***Re: Narrabri Gas Utilisation Project, Narrabri LGA (07\_0023)***

In response to the request for further information (received via email 26 September 2008) on various issues outstanding in Planning NSW's assessment of the proposed Narrabri Gas Utilisation Project, please find enclosed the following detailed submission.

Figure 3. Areas identified as suitable for like for like vegetation offsets

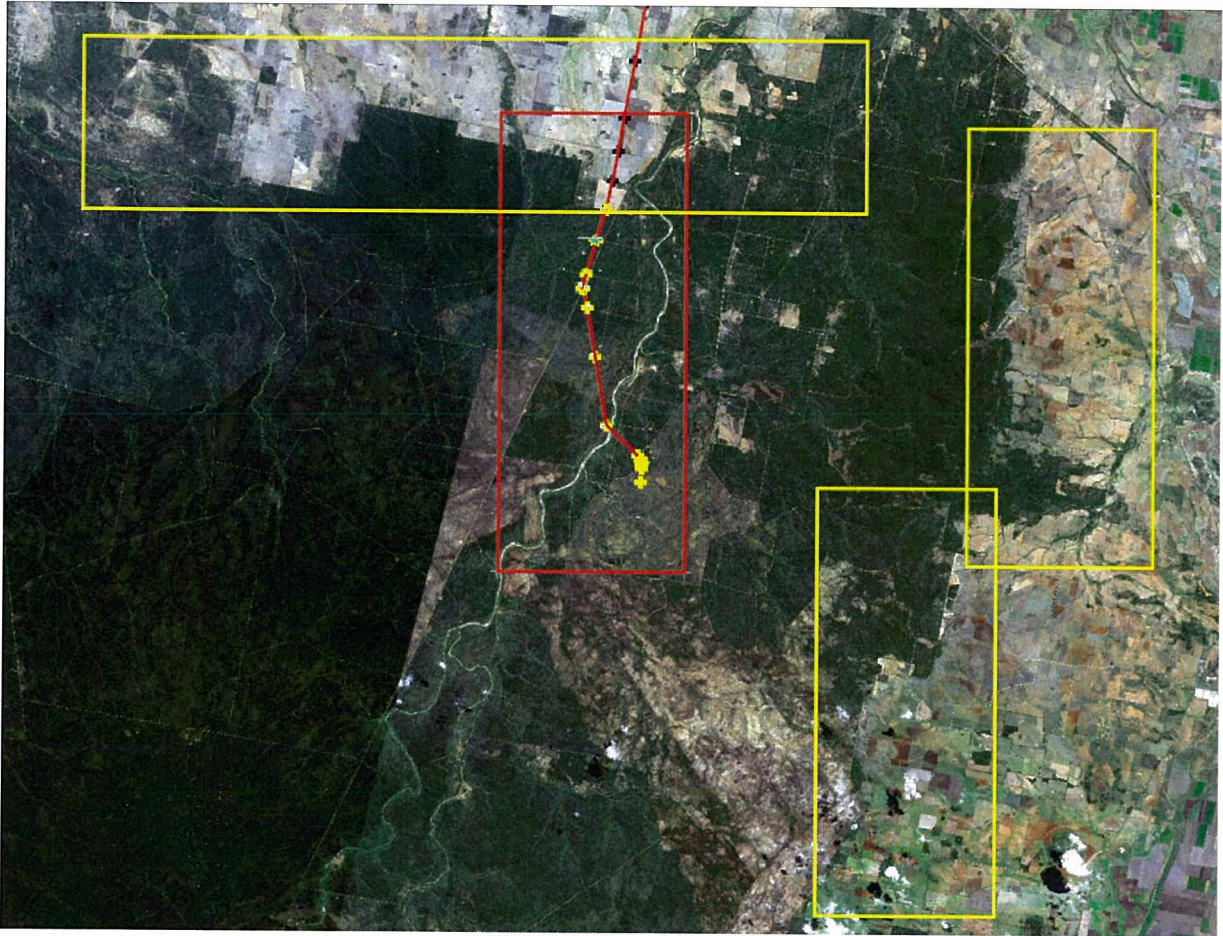
8. *Provide details on how biodiversity offsets are to be achieved. Potential biodiversity offset sites must be identified now, to demonstrate that a viable offset outcome could be achieved. This should reflect the likely scale of the offset required and the availability of land.*

- Areas identified as potentially suitable for vegetation offsets ('like for like') include areas on the forest/farmland interface where woodland remnants of poorer quality can be readily accessed, rehabilitated and protected (maintain/improve).

EXISTING, APPROVED AND  
PREDICTED NOISE LEVELS  
AROUND WILGA PARK  
POWER STATION

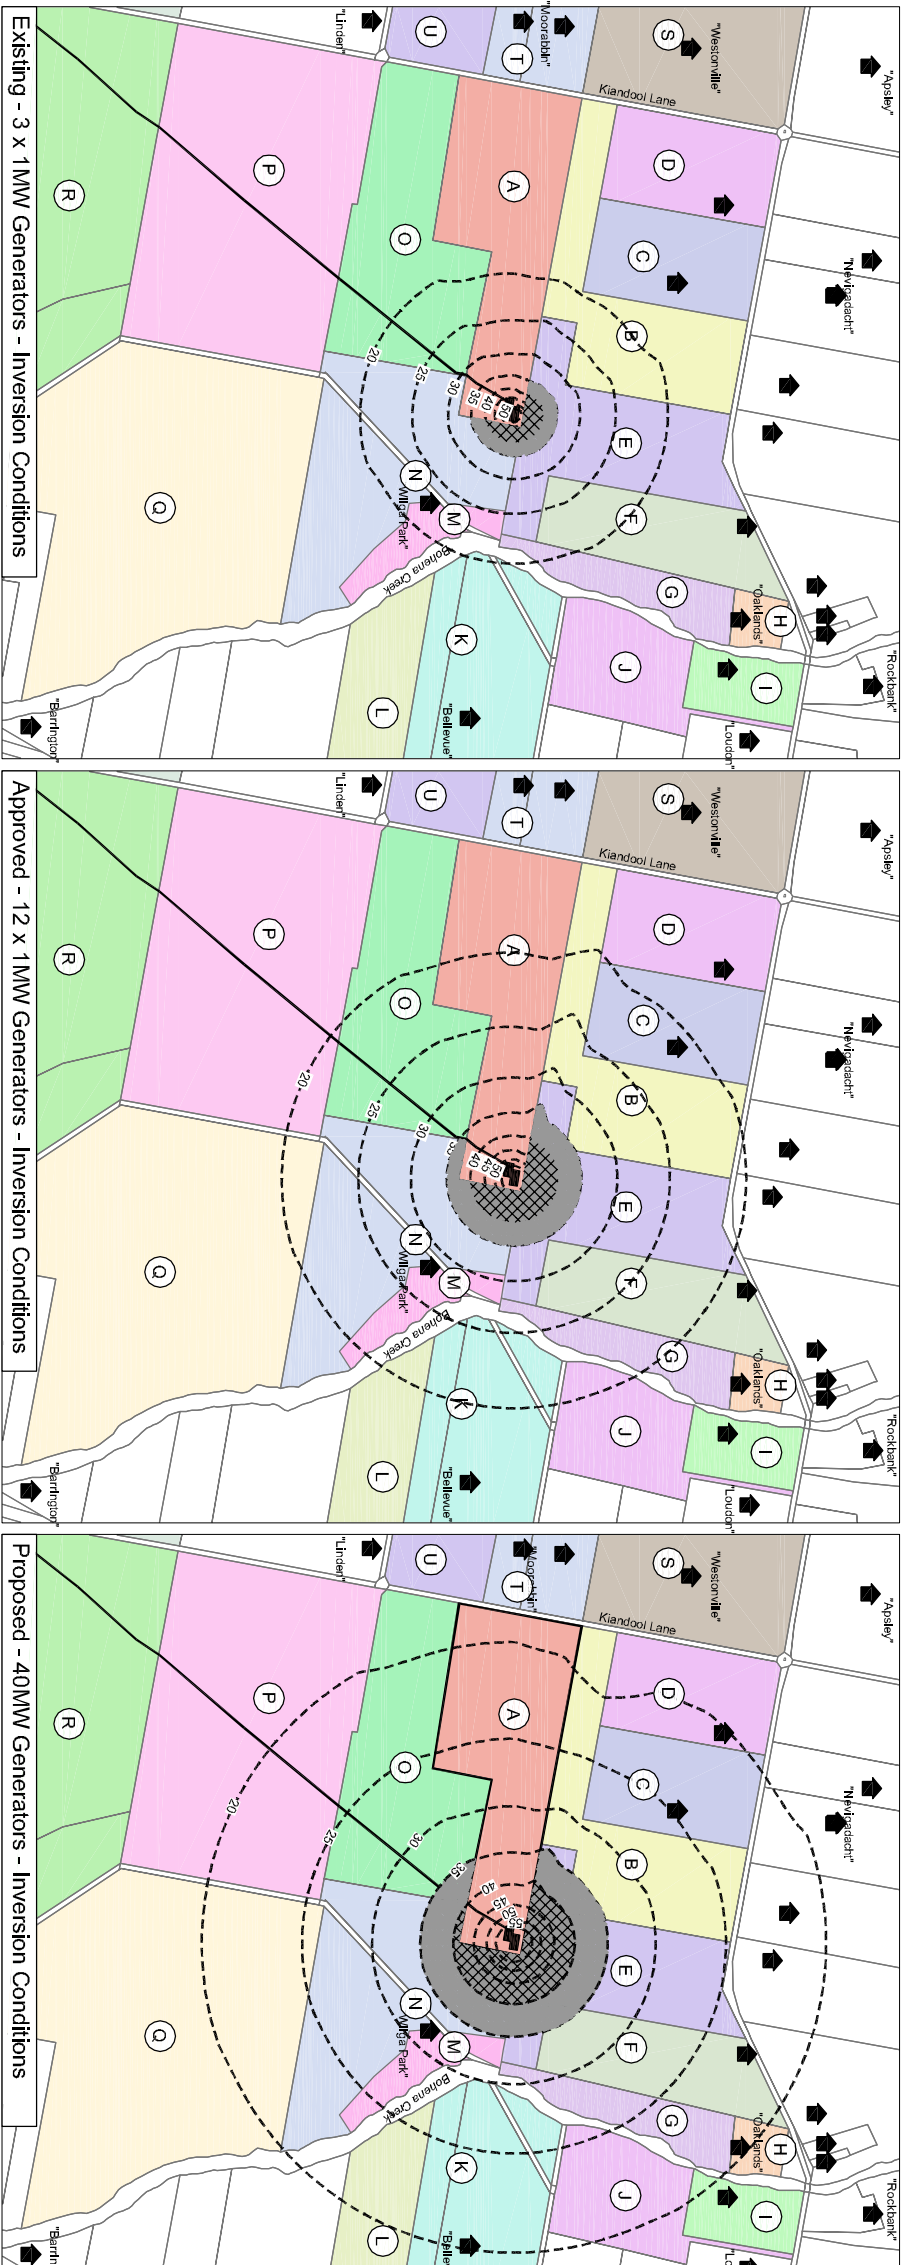
*10. Additional noise impact assessment information – 12 x 1MW scenario*

- *The percentage of land that is noise affected as a result of the approved development on site; and*
- *The percentage change in noise affected land that would result from the current proposed project.*

The percentage of land that is noise affected as a result of the current approved development is shown in table 5.19 (amended) below. The operation of up to 12 x 1MW units at Wilga Park and the noise impacts associated with this scenario have been modelled as affecting three adjoining blocks, two of which are vacant. 24% of the Hardcastle block (vacant), 11% of the Archer block (vacant) and 0.2% of the Cochrane block will be affected by greater than background noise levels under temperature inversion conditions. Percentage figures for this climatic phenomenon are given here as they represent the worst case scenario.

The percentage change in noise affected land that would result from the current proposed project are found in the two right hand columns of table 5.19 (amended) below. For the blocks closest to the Wilga Park facility, the percentage change from the 12 x 1MW scenario (currently approved) to the maximum generating capacity of 40MW is:

Amended noise contour maps for the current, current approved and proposed scenarios have been formulated and are enclosed.
